SERVICE BULLETIN

N° 139-462

ATA 25 - INSTALLATION OF ACTIVE NOISE REDUCTION HEADSET

This Service Bulletin is issued in order to provide the necessary instruction on how to perform the installation of kit active noise reduction headset P/N 4G2350F00113.

Figure 1

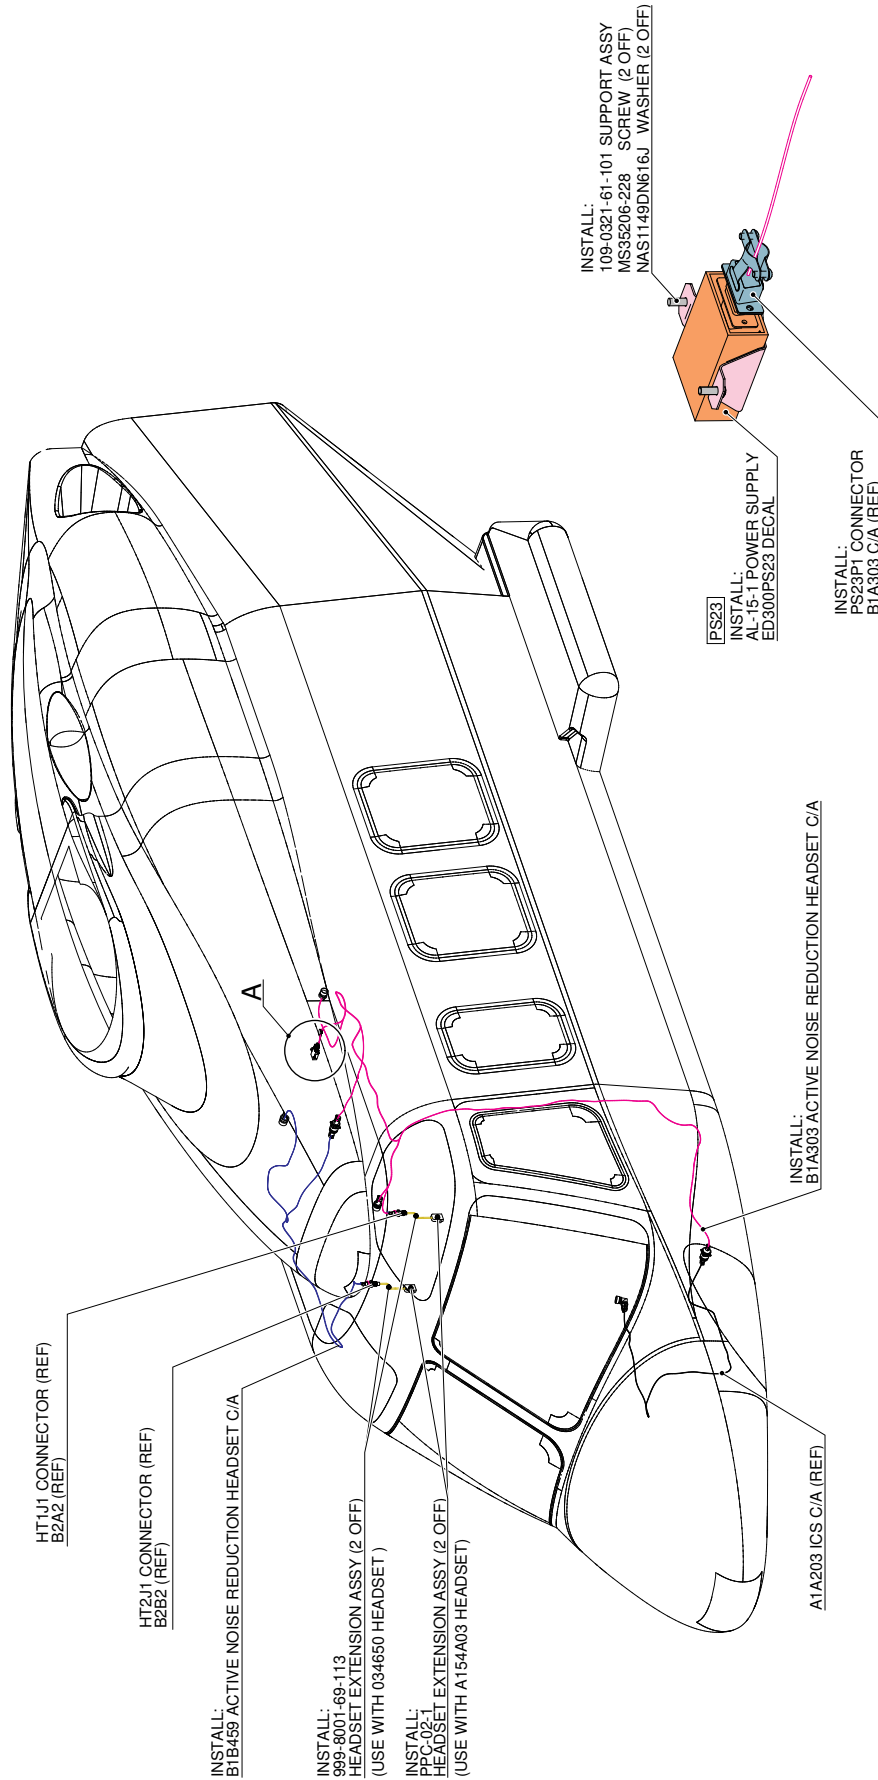
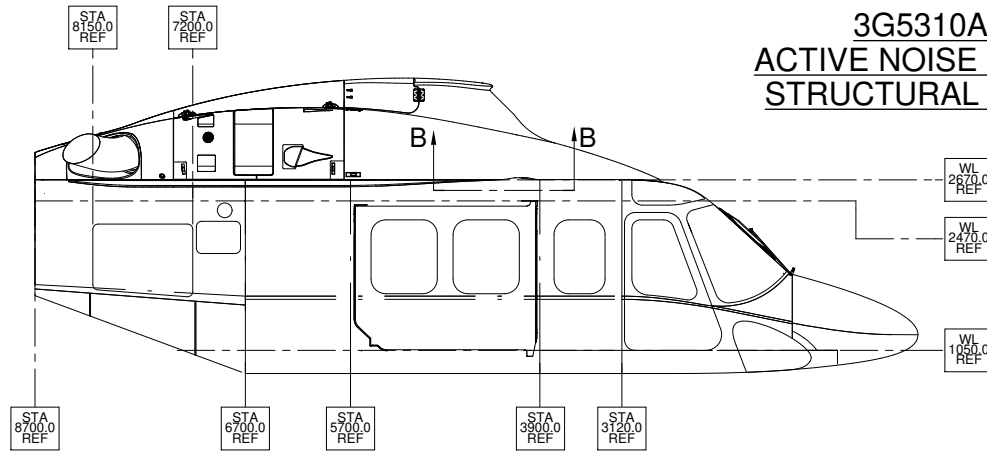
4. In accordance with AMP DM 39-B-25-18-01-00A-720A-K and with reference to Figure 1 detail A, install power supply P/N AL-15-1 by means of support assy P/N 109-0321-61-101, n°2 washers P/N NAS1149DN616J and n°2 screws P/N MS35206-228.
5. With reference to Figure 1 detail A, perform the electrical connection between the power supply P/N AL-15-1 and the connector PS23P1.
6. In accordance with AMP DM 39-A-11-00-01-00A-720A-A and with reference to Figure 1, install decal P/N ED300PS23 in an area adjacent to power supply.

7. With reference to Figure 1, install n°2 headset extension assemblies P/N 999-8001-69-113.

8. With reference to Figure 1, install n°2 headset extension assemblies P/N PPC-02-1.
9. Perform a pin-to-pin continuity check of all the electrical connections made.
10. In accordance with Annex A, perform the active noise reduction system functional test.
11. In accordance with weight and balance changes, update the Chart A (see Rotorcraft Flight Manual, Part II, section 6).
12. Return the helicopter to flight configuration and record for compliance with this Service Bulletin on the helicopter logbook.
13. Send the attached compliance form to the following mail box:

Figure 2

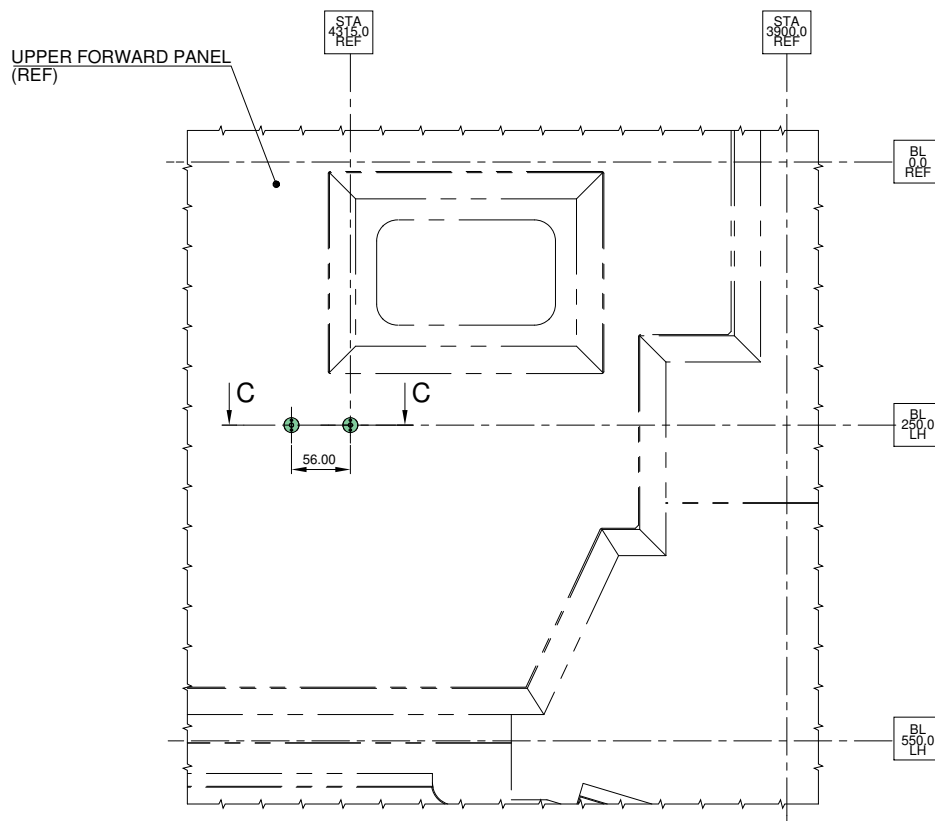
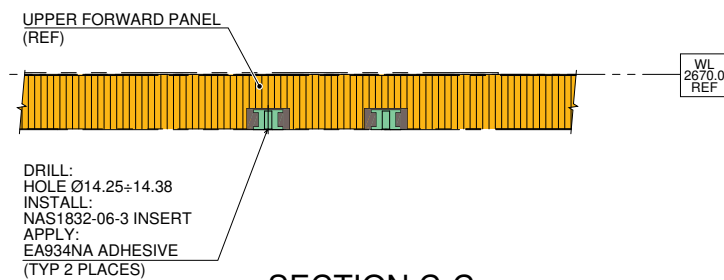
- 2.1 With reference to Figure 2 view B-B and section C-C, temporarily locate support assy P/N 109-0321-61-101 and countermark positions of n°2 holes on upper forward panel.

- 2.2 With reference to Figure 2 view B-B and section C-C, drill n°2 holes $\varnothing 14.25 \pm 14.38$ in correspondence of previously marked position on upper forward panel.

- 2.3 In accordance with CSRP DM CSRP-A-51-42-00-00A-720A-D and with reference to Figure 2 view B-B and section C-C, install n°2 inserts P/N NAS1832-06-3 by means of EA934NA adhesive.

Figure 3

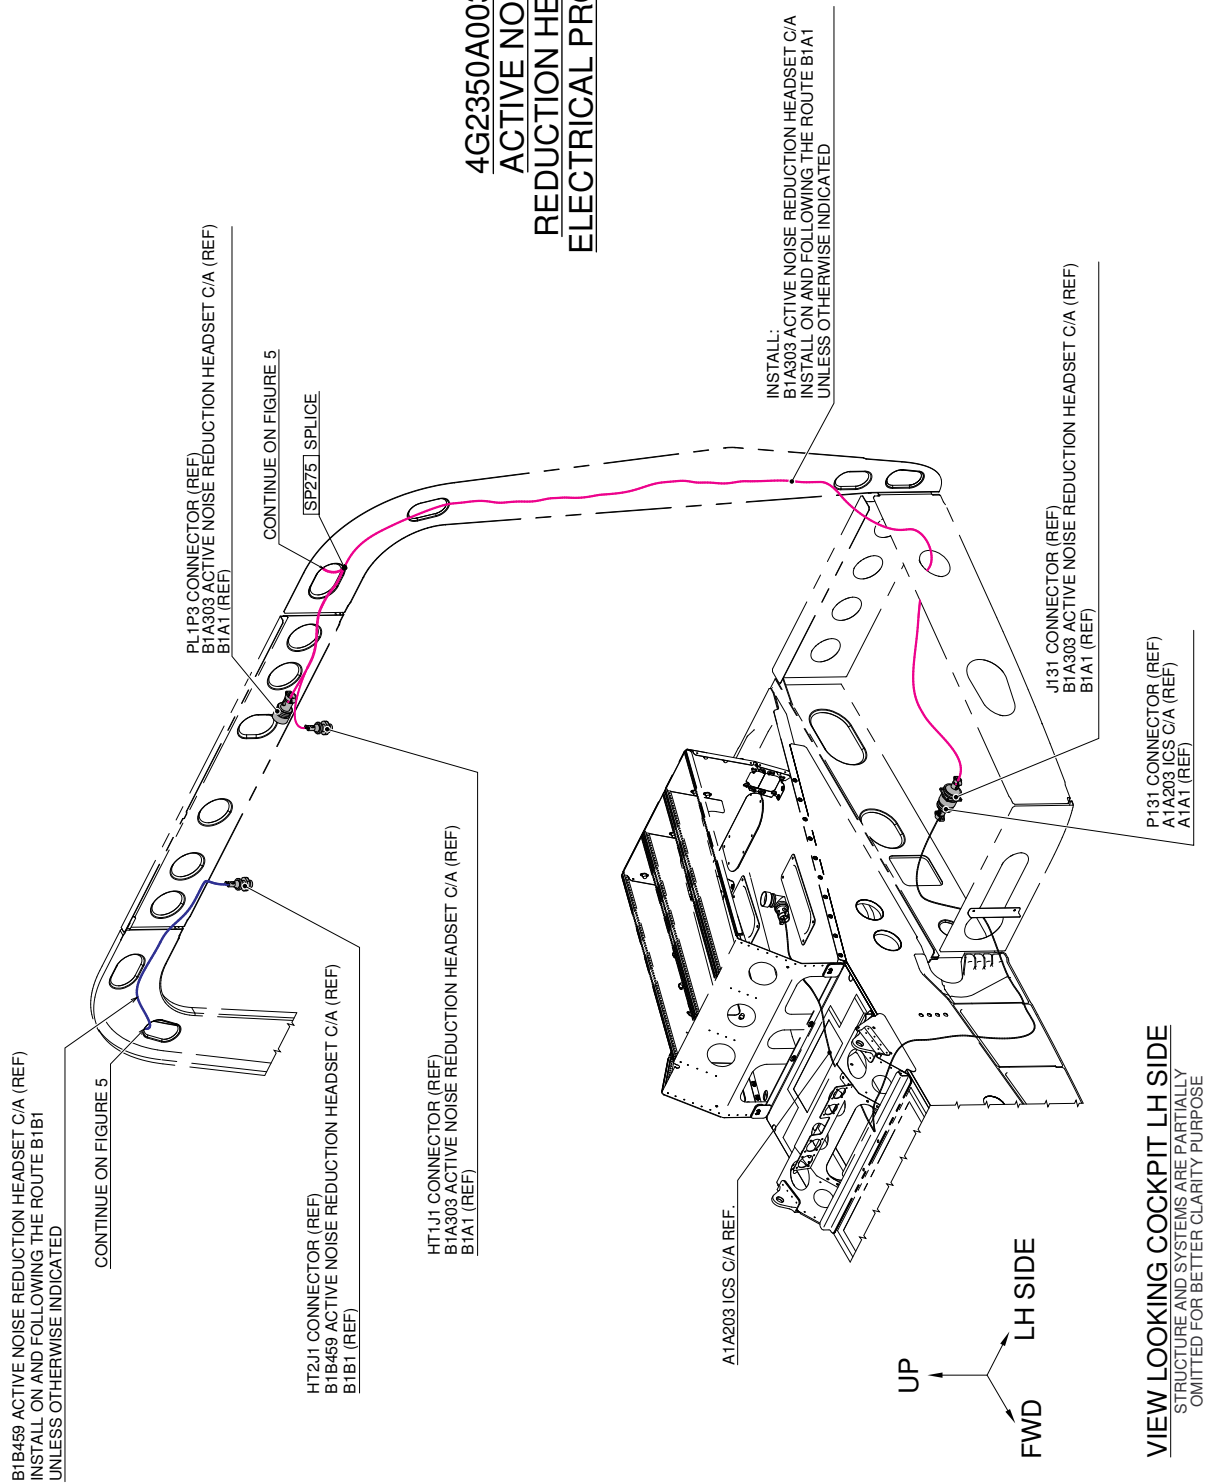
- 3.4 With reference to Figures 3 thru 5, lay down the following cable assemblies following the existing route unless otherwise indicated on the figures:
 - Active noise reduction headset C/A (B1A303) P/N 3G9B01A30301;
 - Active noise reduction headset C/A (B1B459) P/N 3G9B01B45901.Secure the cables by means of previously installed fixing hardware, existing hardware and lacing cord P/N 900004953.

- 3.5 With reference to Figures 3, 5 and Figure 6 wiring diagram, perform the electrical connection of cable assy P/N 3G9B01A30301 (B1A303) between the sectioning connector J131, the circuit breaker panel connector PL1P3 and the power supply

Figure 4

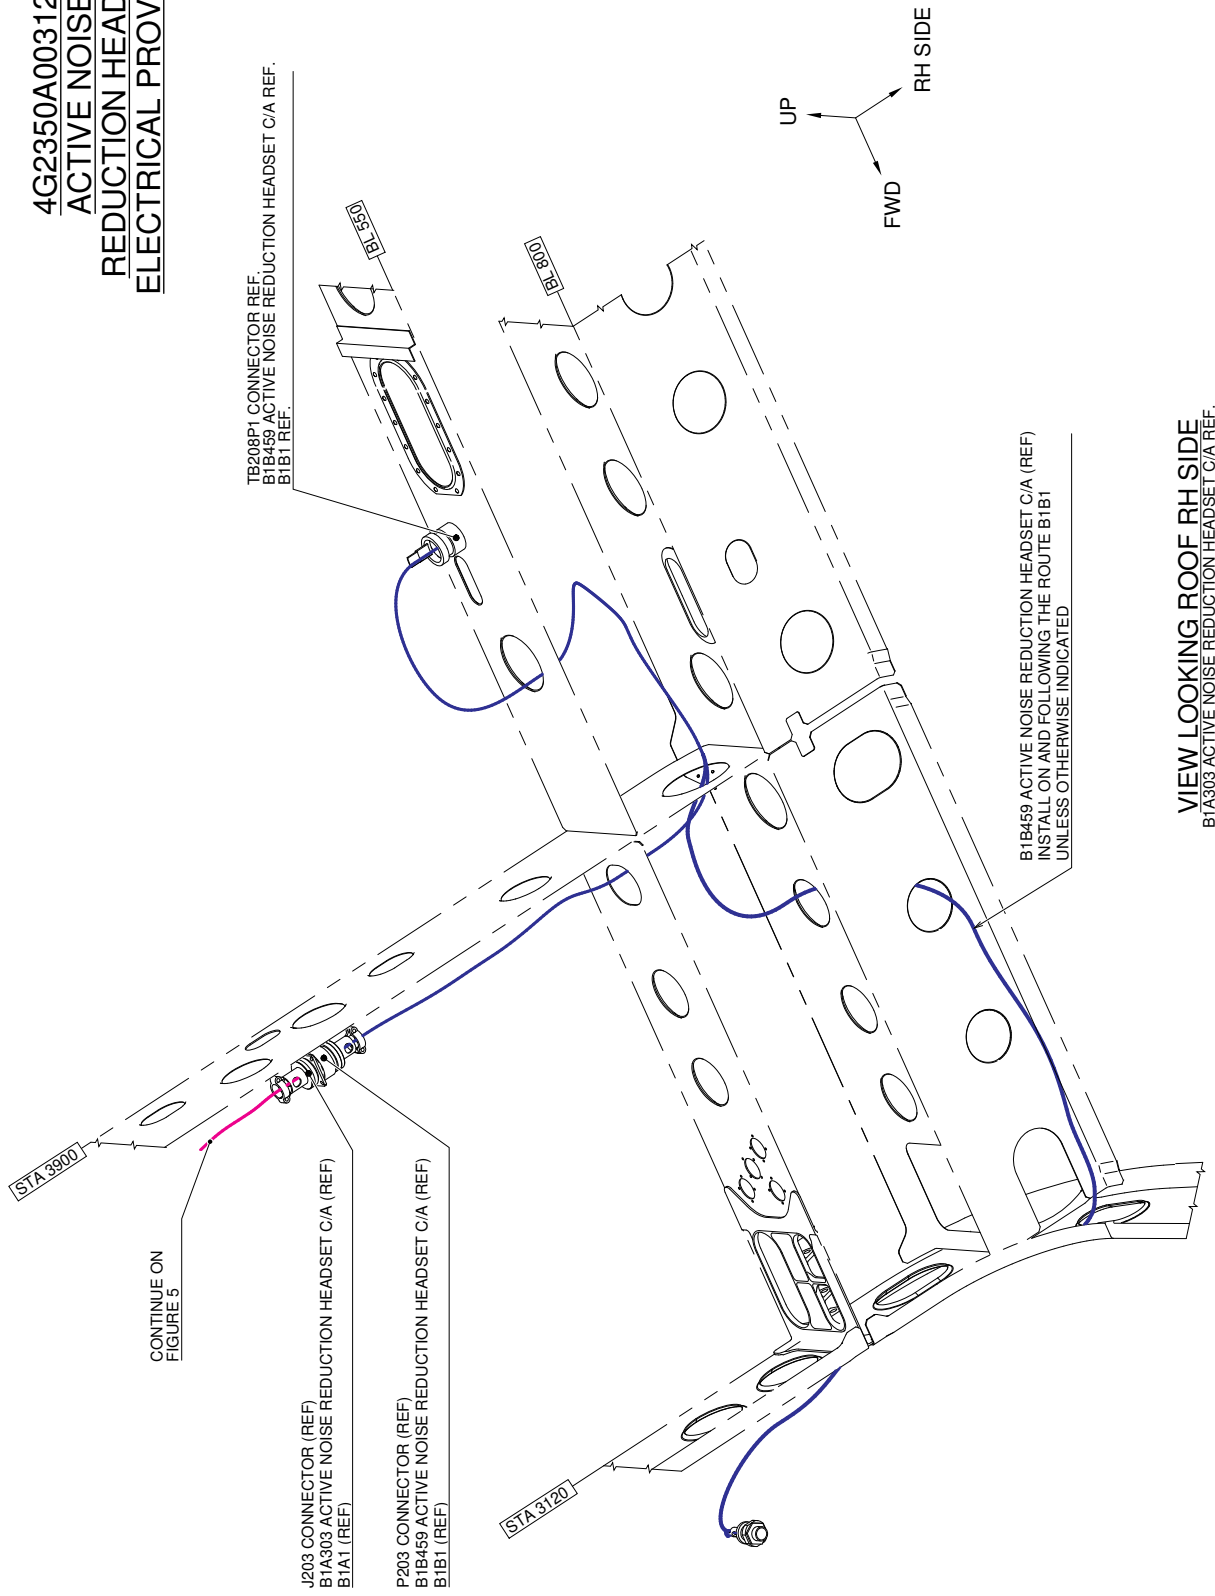
3.6 With reference to Figures 3, 4, 5 and Figure 7 wiring diagram, perform the electrical connection of the cable assy P/N 3G9B01A30301 (B1A303) between co-pilot headset connector HT1J1, DC POWER GND terminal board TB209P1, sectioning connector J203 and power supply connector PS23P1. If necessary use the following electrical contacts:

3.7 With reference to Figures 3, 4 and 7 wiring diagram, perform the electrical connection of the cable assy P/N 3G9B01B45901 (B1B459) between pilot headset connector HT2J1, sectioning connector P203 and DC PWR GND terminal board TB208P1. If necessary, use the following electrical contacts:

Figure 5

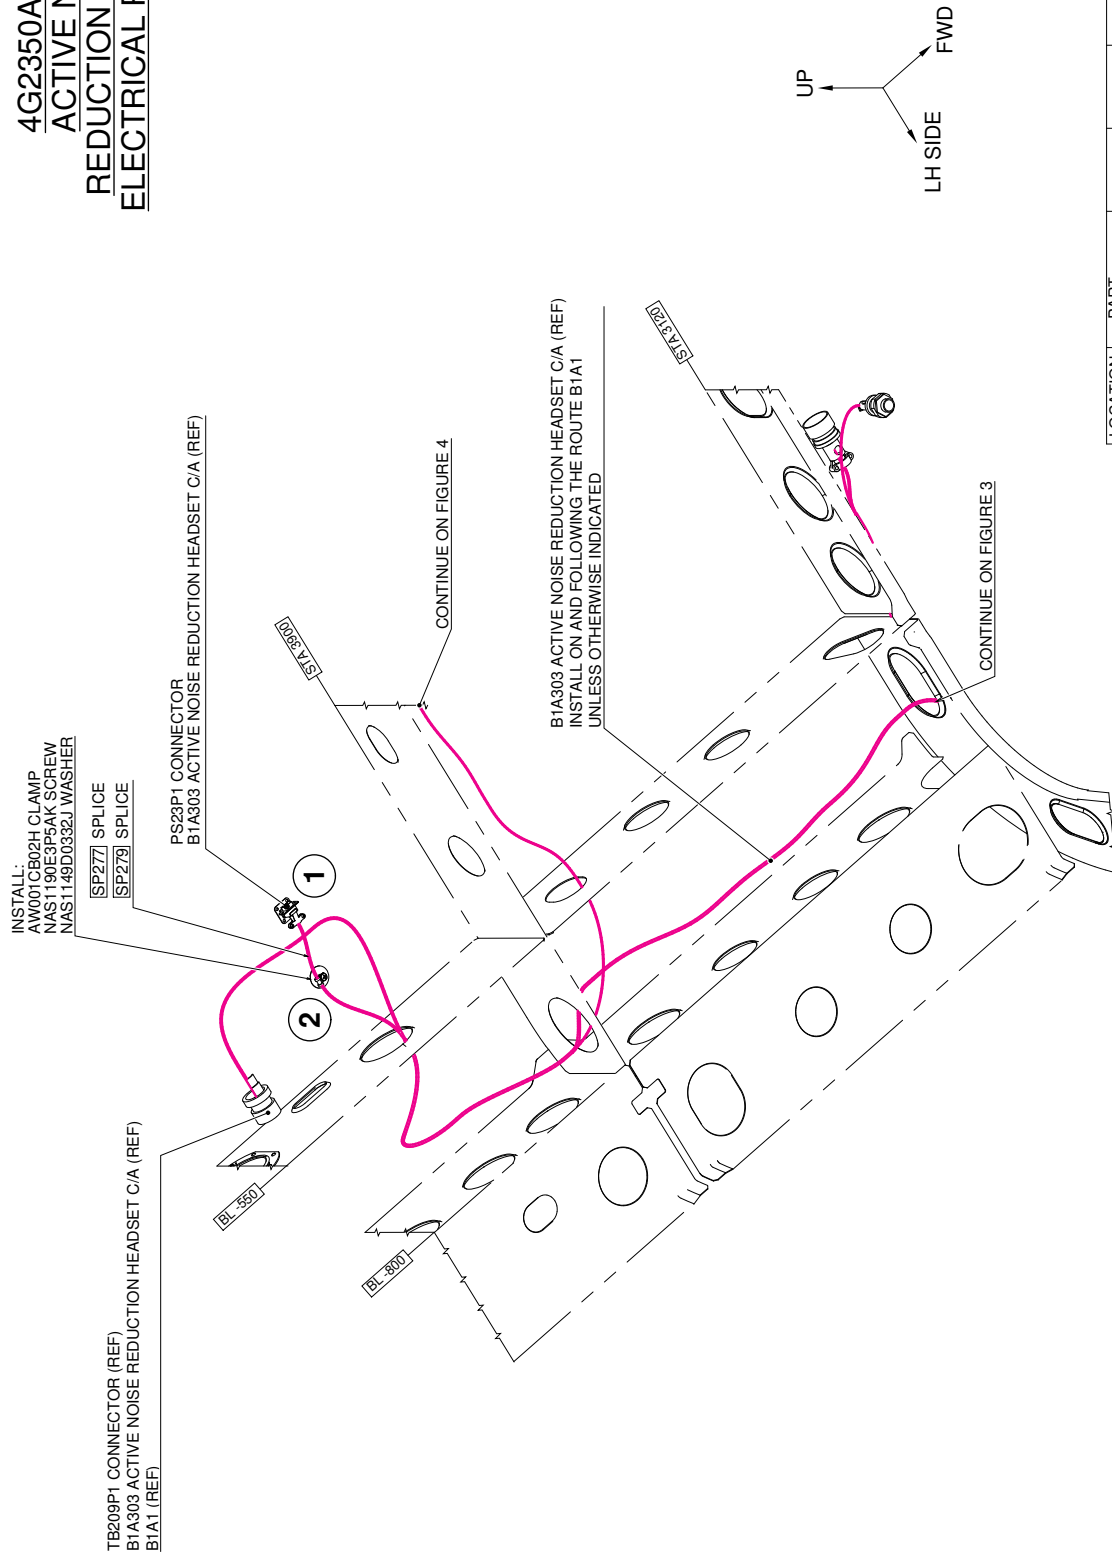
- 3.1 With reference to Figure 5, at location n°1, install support P/N AW001CL001-N6 by means of adhesive EA9309.3NA (C021).
 - 3.2 In accordance with AMP DM 39-A-20-10-09-00A-920A-A and with reference to Figure 5, at location n°2, install support P/N A388A3E06C by means of adhesive EA9309.3NA (C021) and install clamp P/N AW001CB02H by means of washer P/N NAS1149D0332J and screw P/N NAS1190E3P5AK.

Figure 6

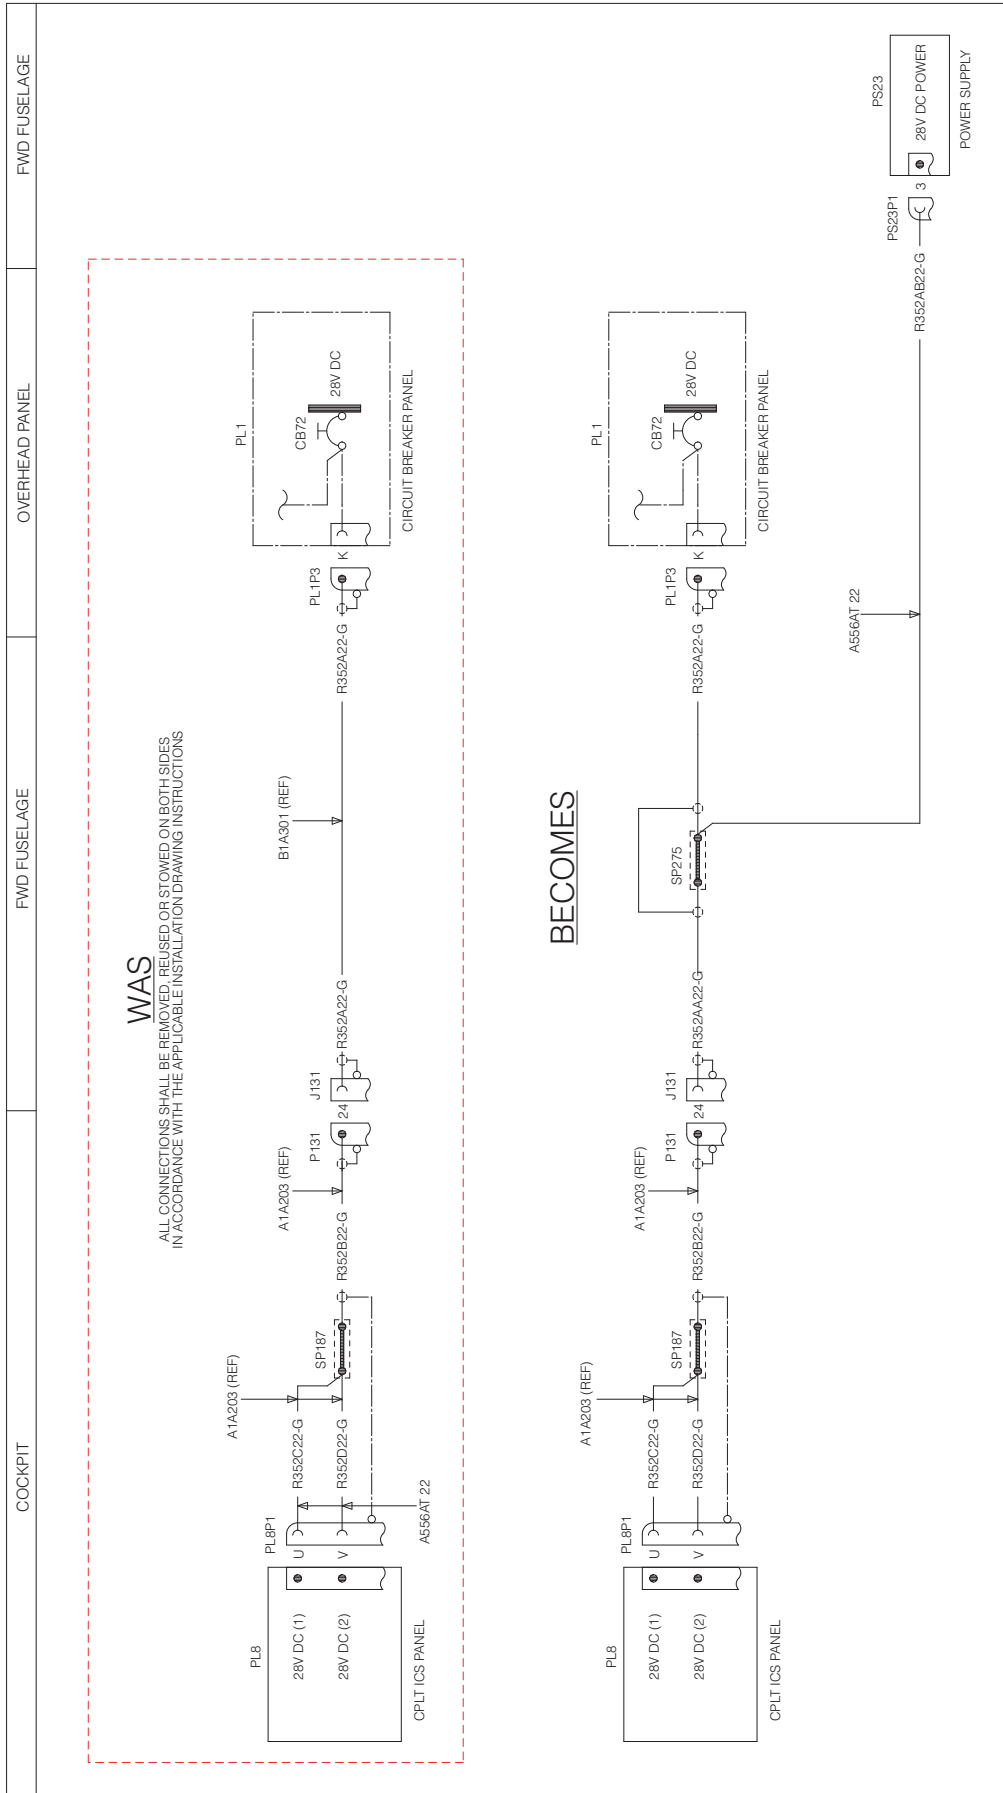
- 3.3 With reference to Figure 6 wiring diagram, remove the electrical connection of the cable assy B1A301 between the sectioning connector J131 and the circuit breaker panel connector PL1P3.
